# Paulding County Environmental Health

Re: Cumberland Falls S/D

**LEVEL III SOIL SURVEY**  
for PERMITTING OF ON-SITE WASTEWATER SYSTEMS

FINAL PLAT WITH SOILS  
**CUMBERLAND FALLS**

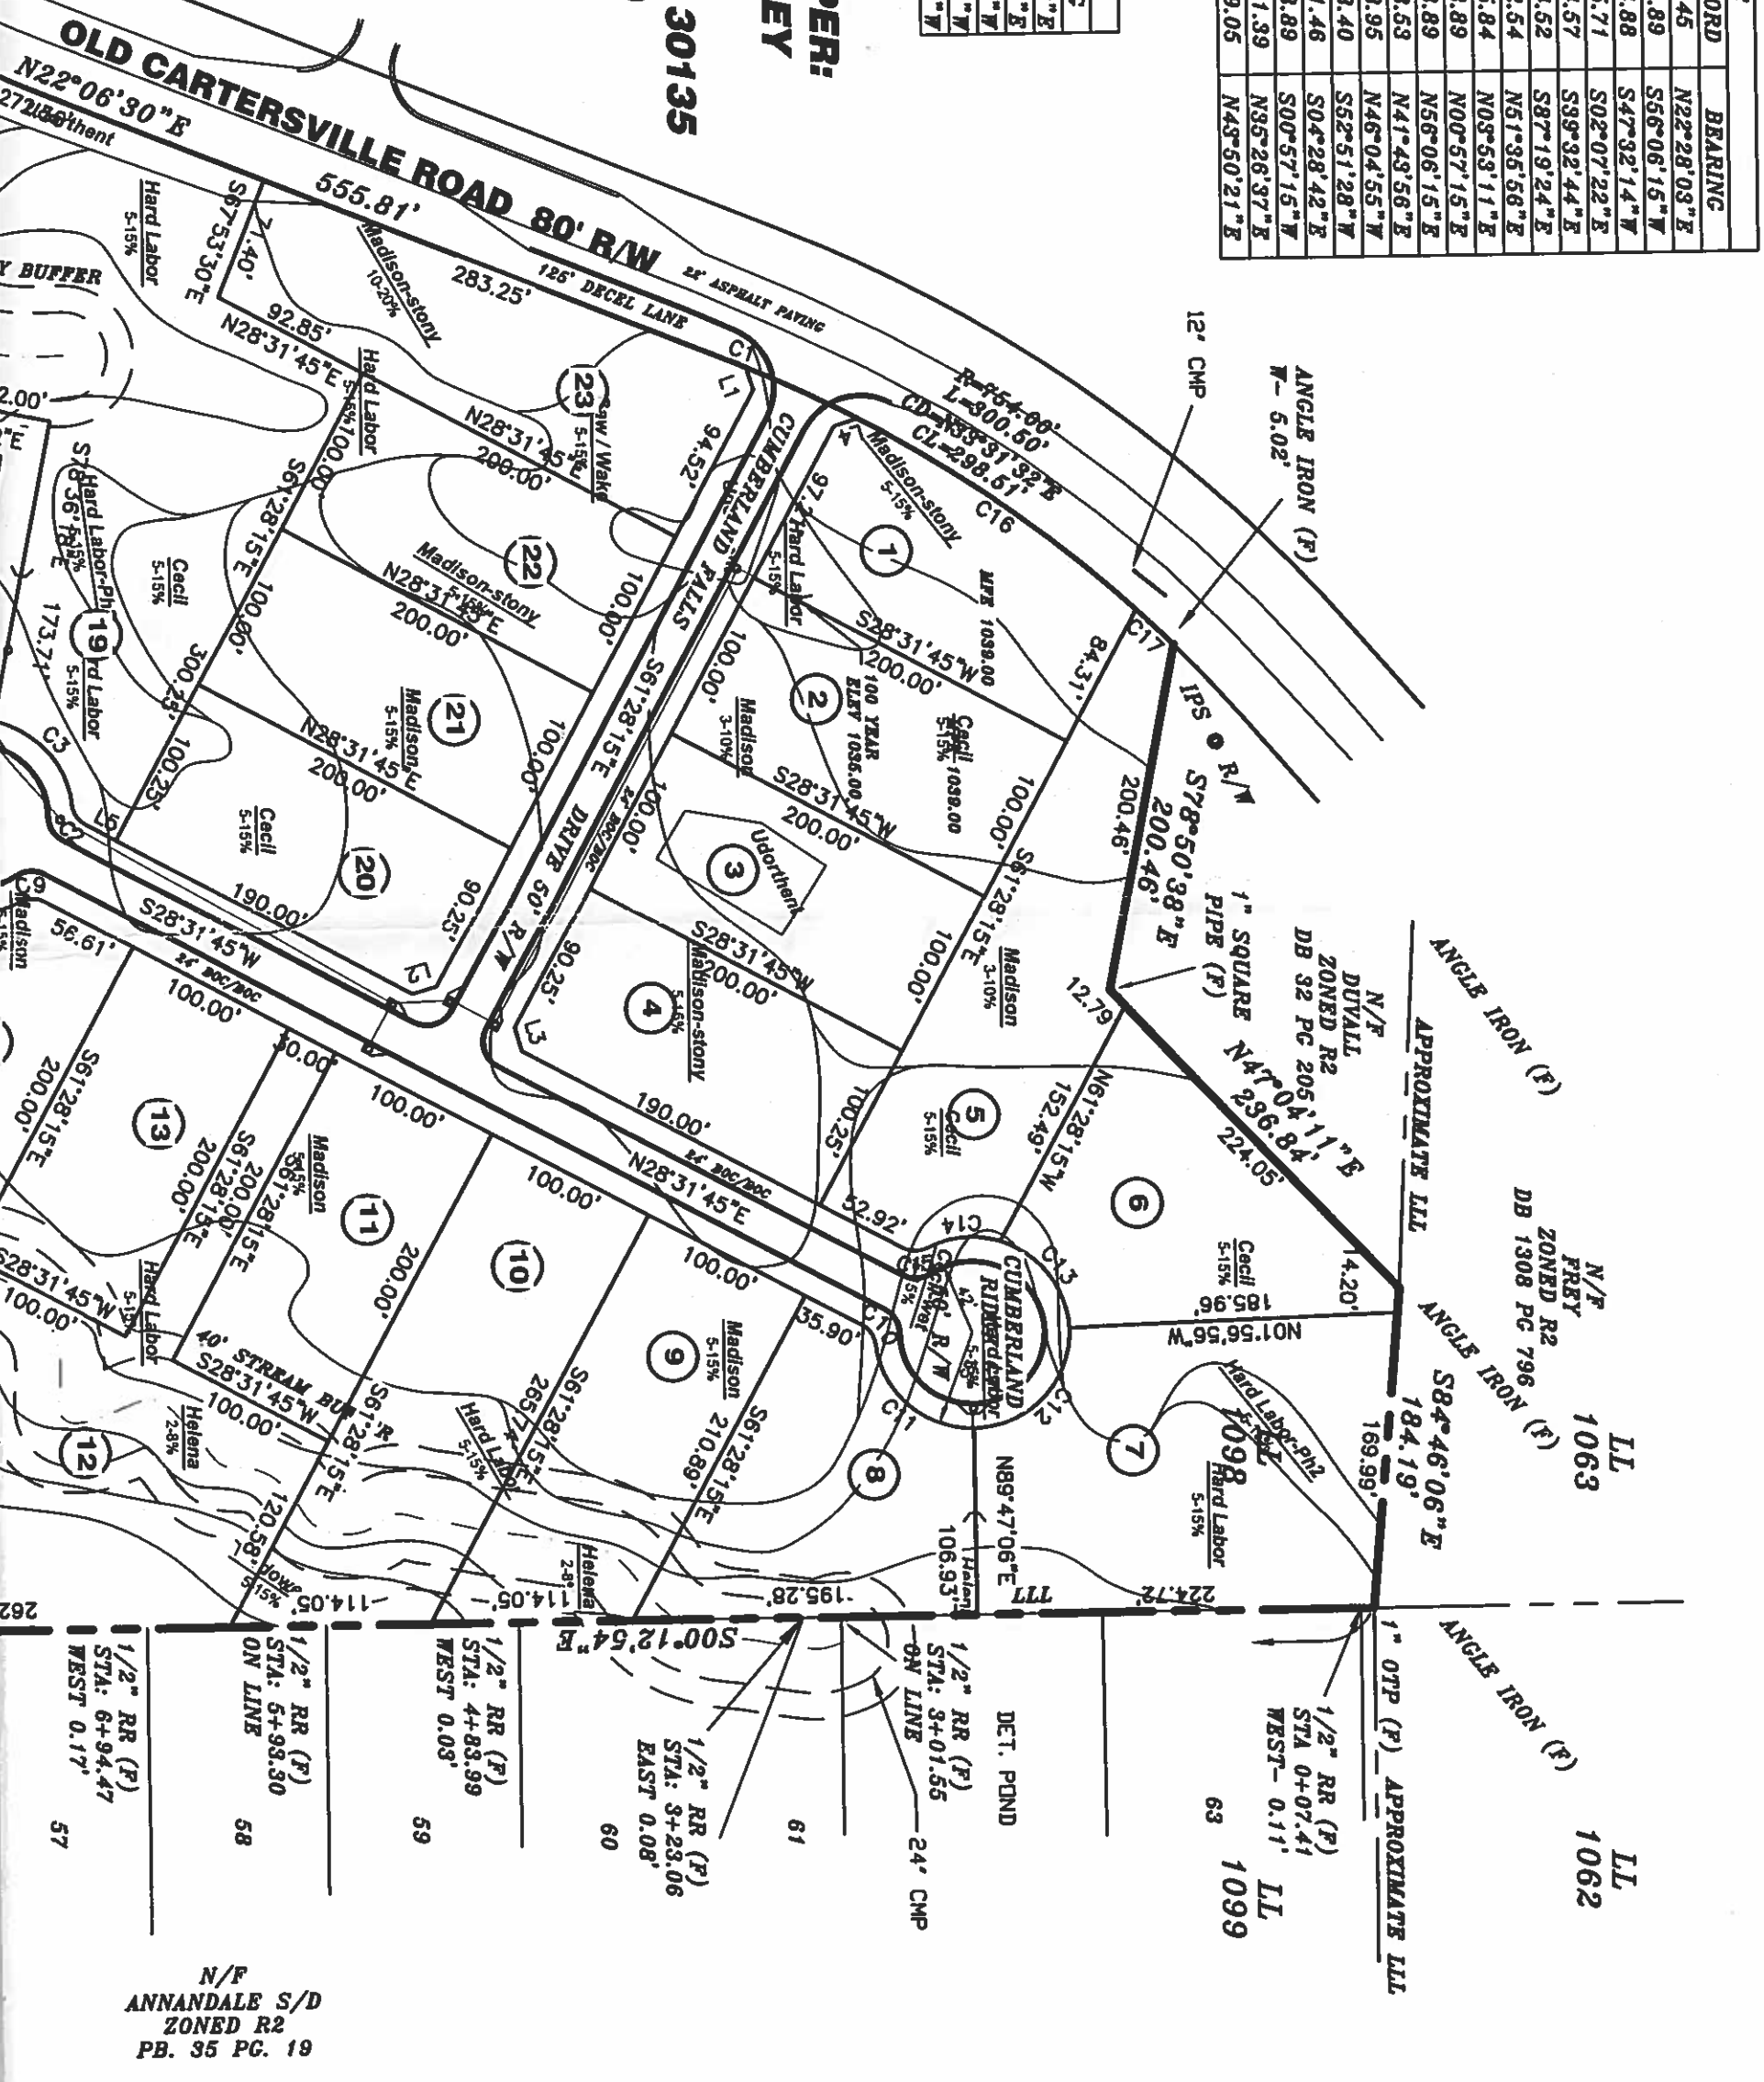
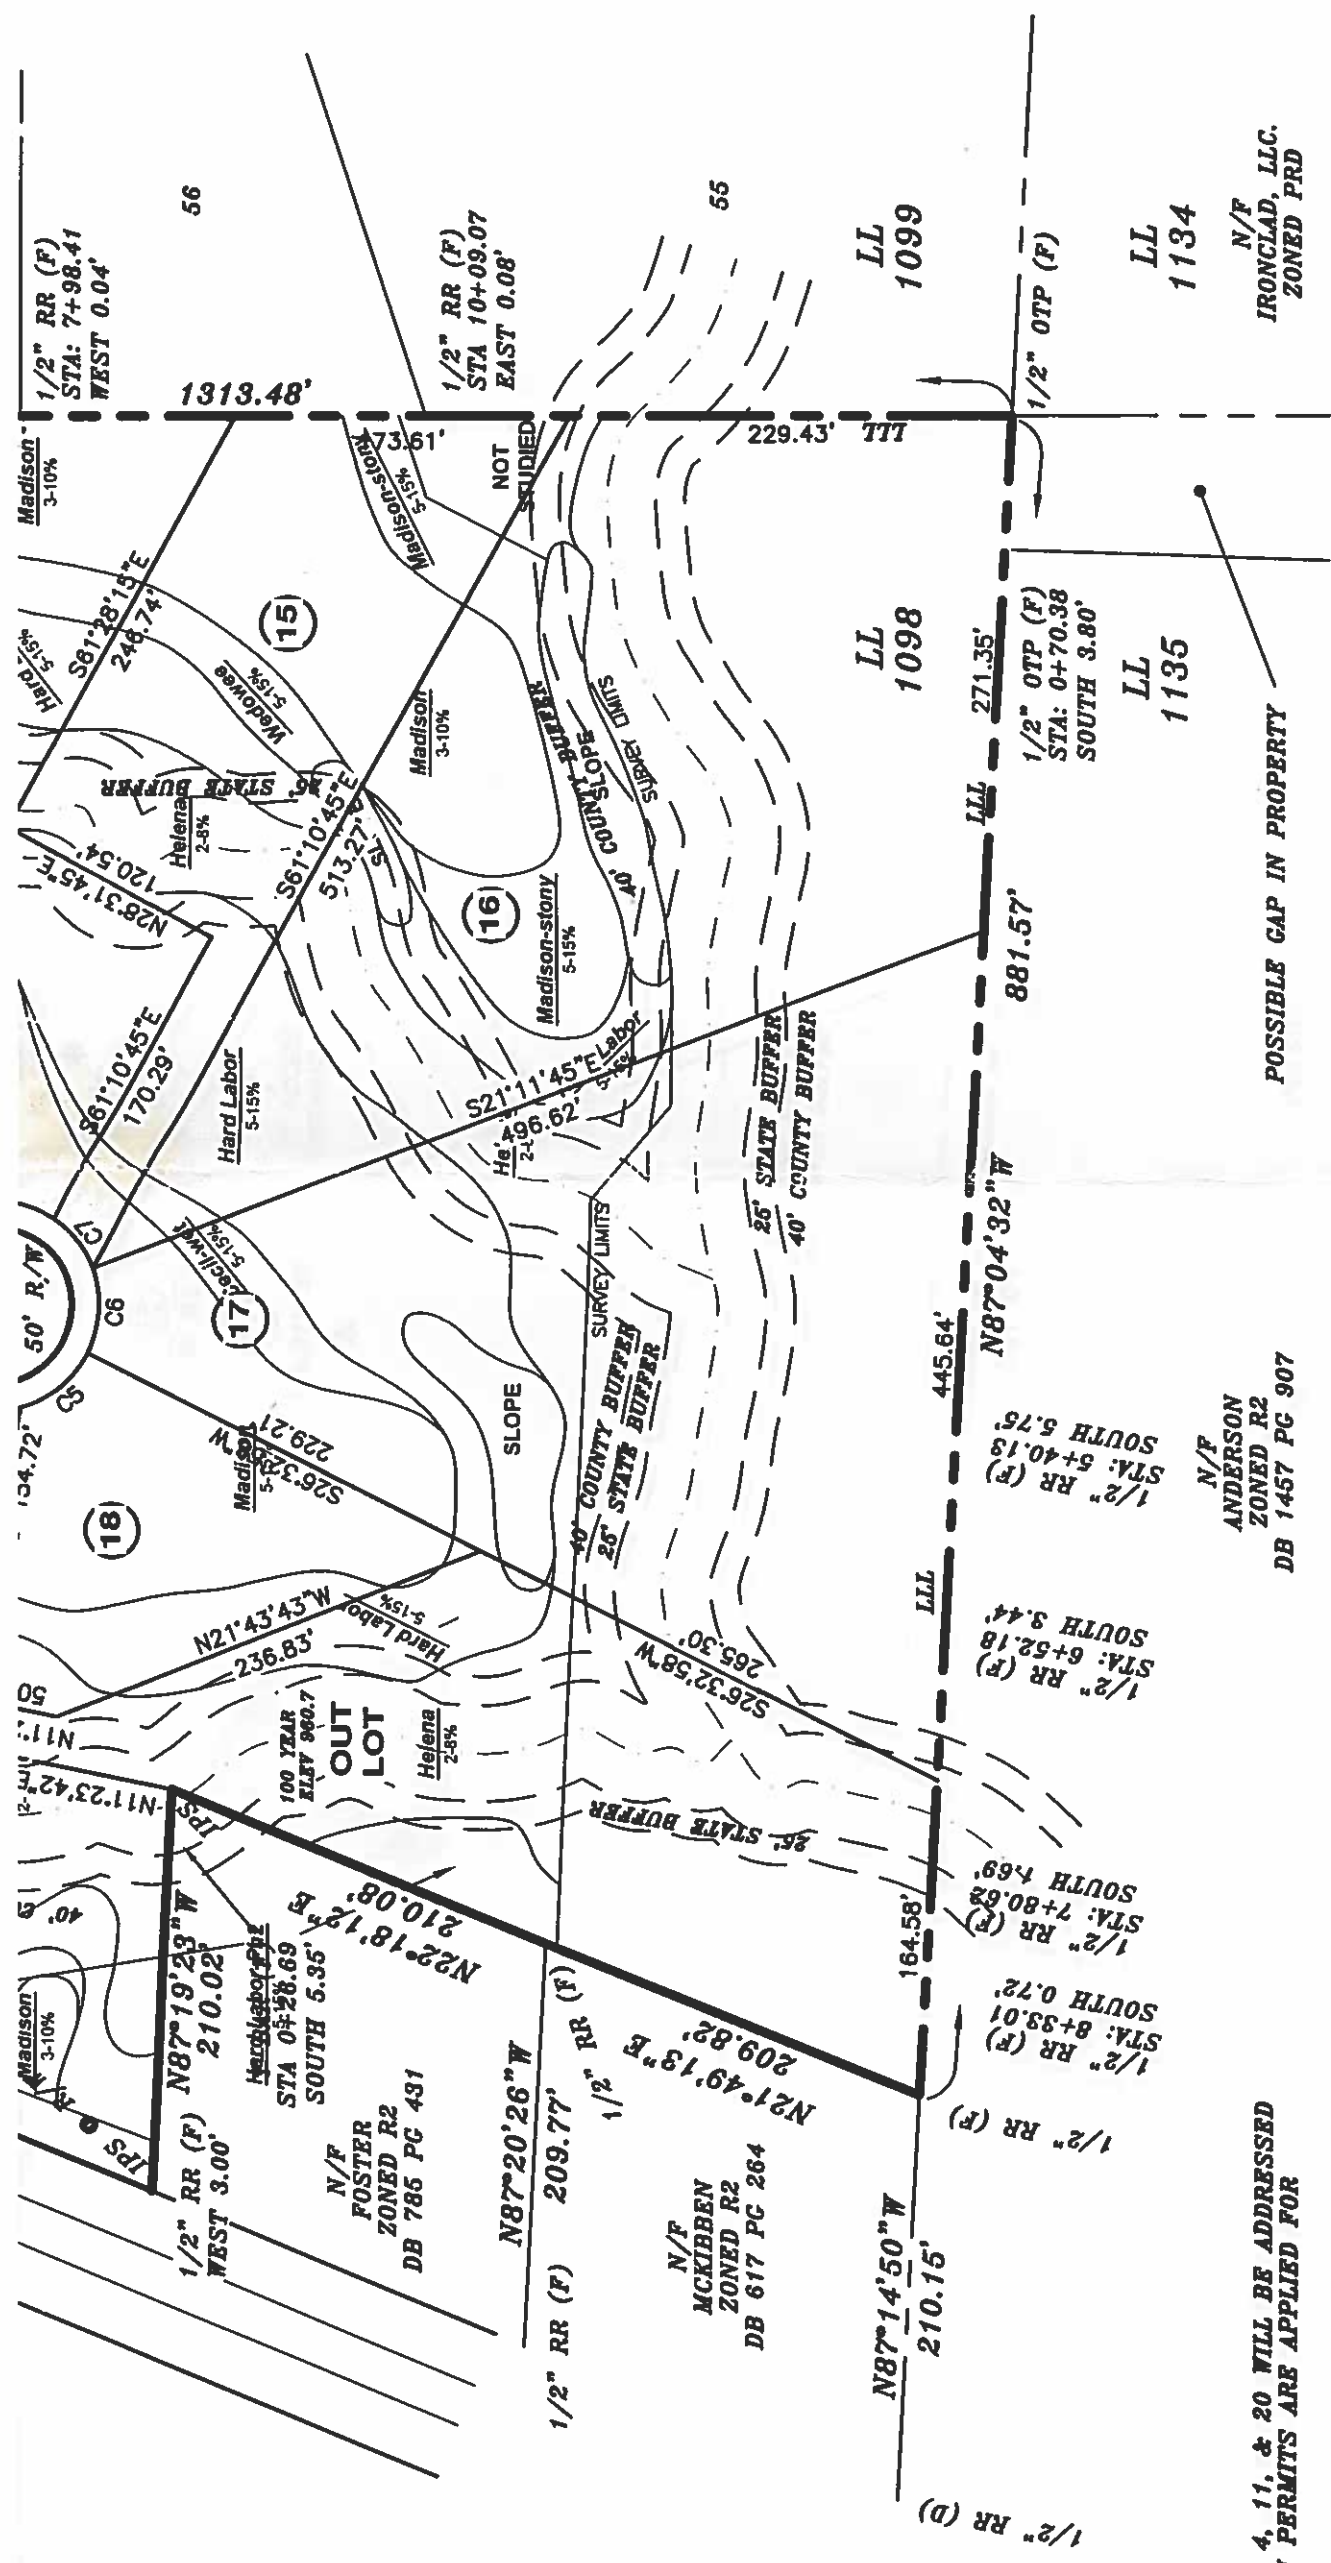
After reviewing the level III soil report along with the final plats, lots 7, 8, 12, 14, 16, 17, 19, and 23 will require site plans. Additional site plans may be required after site visits to all lots have been made.

Please be aware that Madison-Stony soils may require additional drainline after installation depending on the amount of rock features encountered. This is based on the suitability code "B" for Madison-Stony soils. Also note that if Saw/Wake soils are used additional soil work in the form of test pits will be required.
